ORIGINATION FORM

Proposed Revisions to a Standard Plans Index
(Please provide all information — Incomplete forms will be returned)

Index Number: 646-001
Sheet Number (s): 1 of 1
Index Title:
Aluminum Post and Pedestal Mounted
Pedestrian Detectors and Signals

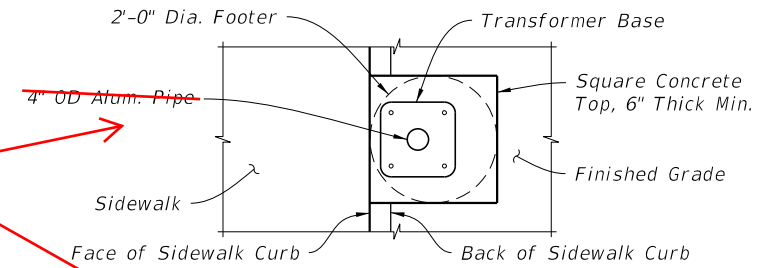
1. Work this Index with Specification 646.
2. For Pedestrian Signals see Index 653-001.
3. For Pedestrian Detector Assembly (i.e., Pushbutton and Sign) details see Index 665-001.
4. ~~Construct footing with Class I Concrete, footing may be Cast-In-Place (C-I-P) or Precast.~~

DELETE CLASS I REFERENCE IN NOTE 4

5. ADDED NOTE 5

PLAN VIEW SECTION B-B

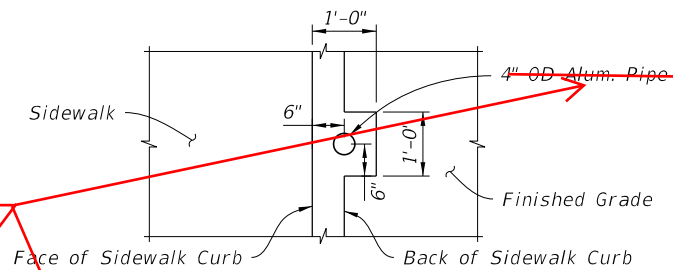
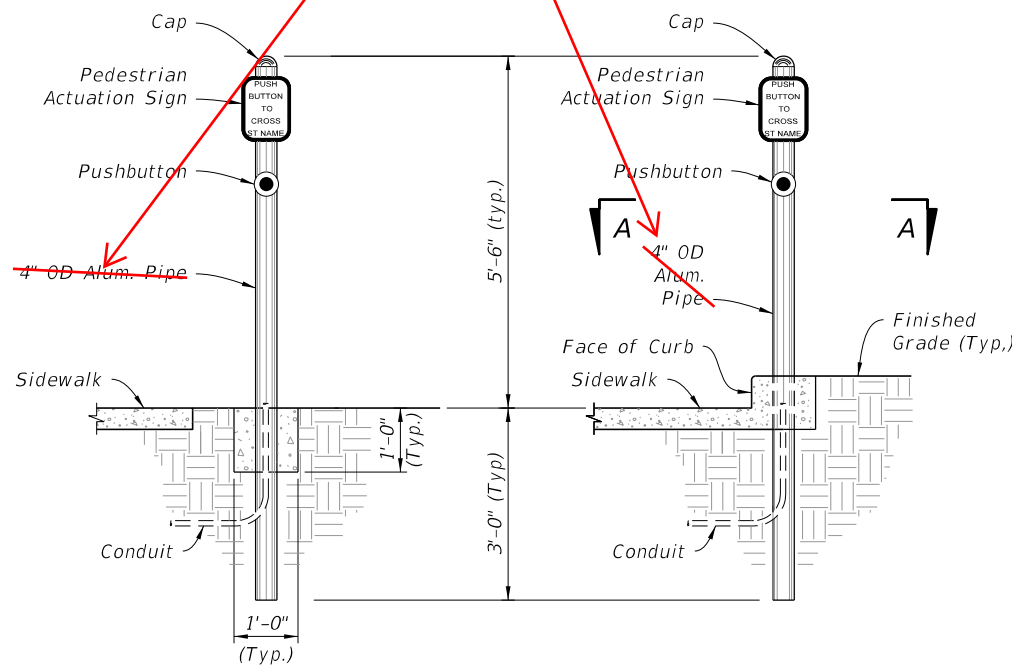
CHANGED TO: Nominal 4" Aluminum Pole (Sch. 40) (4.5" OD)

CHANGED TO: Nominal 4" Aluminum Post (Sch. 40) (4.5" OD)

CHANGED TO: #4 Stirrups Equally Spaced, 12" Max.

PEDESTAL MOUNTED

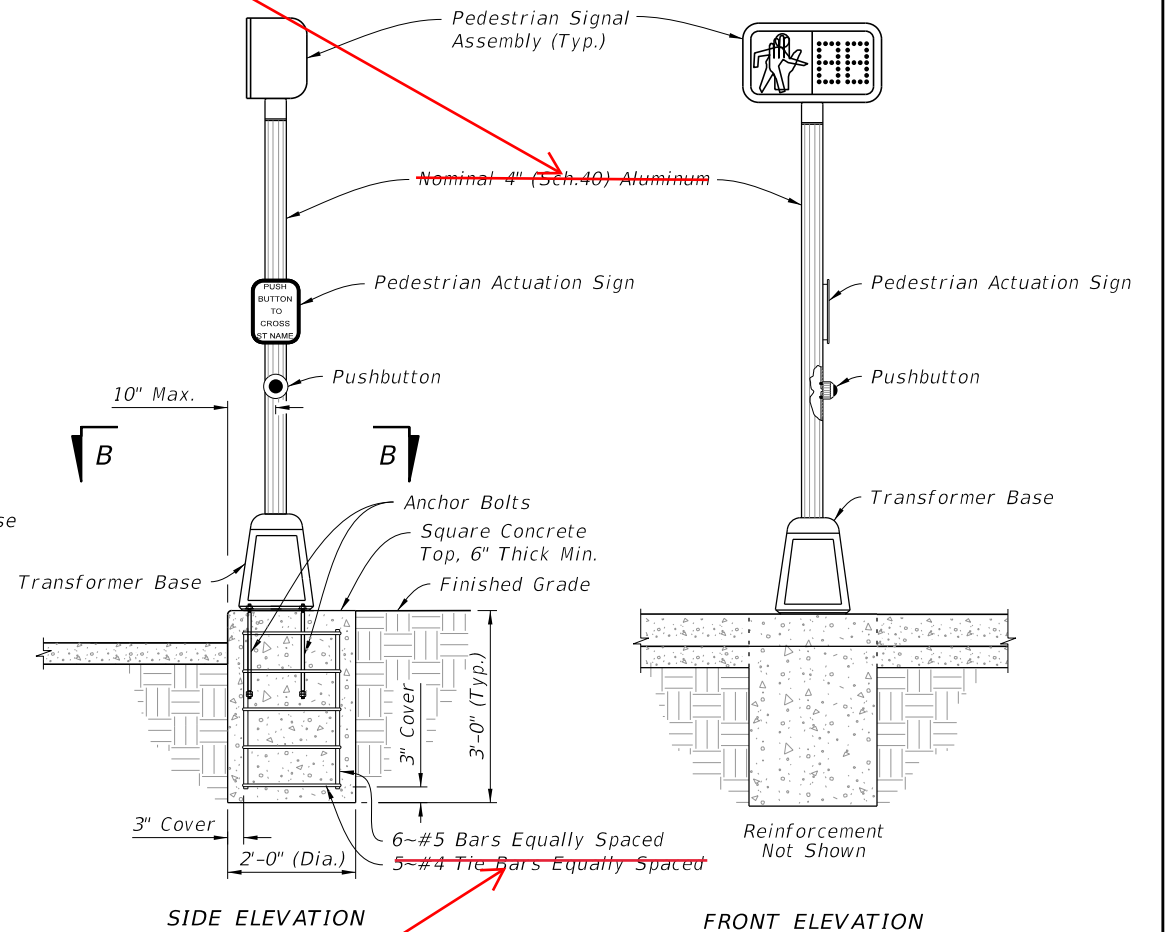
CHANGED TO: #4 Stirrups Equally Spaced, 12" Max.
